WIZARDS WORKSHOP

TEKTRONIX INTERNAL USE ONLY

COMBINATION

PARTIAL, FIGURE 9 - 8

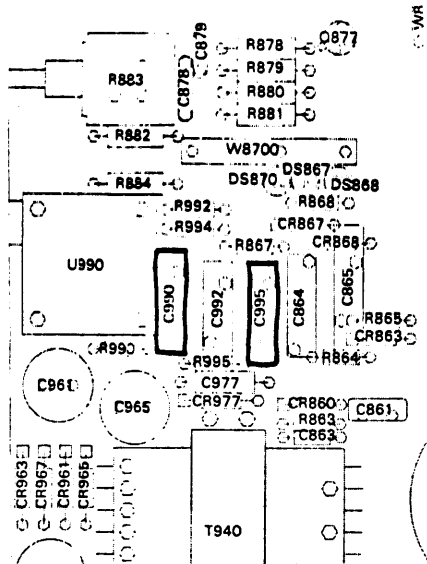
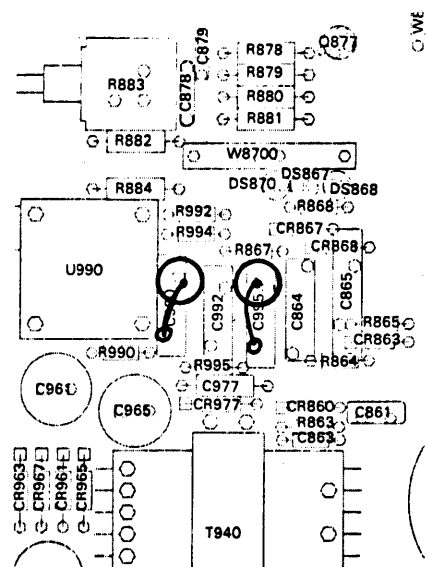
In the listed serial number ranges, capacitors A10C990 and A10C995 in the CRT cathode circuit must be changed to reduce ripple on the cathode and the resulting intensity modulation on the display. The new part number for both capacitors is 285-1184-00. Both will be mounted on end, with the bottom connection to the -2KV (close to the board) and the long lead from the top to the 100Ω resistor junction (R990 or R995).
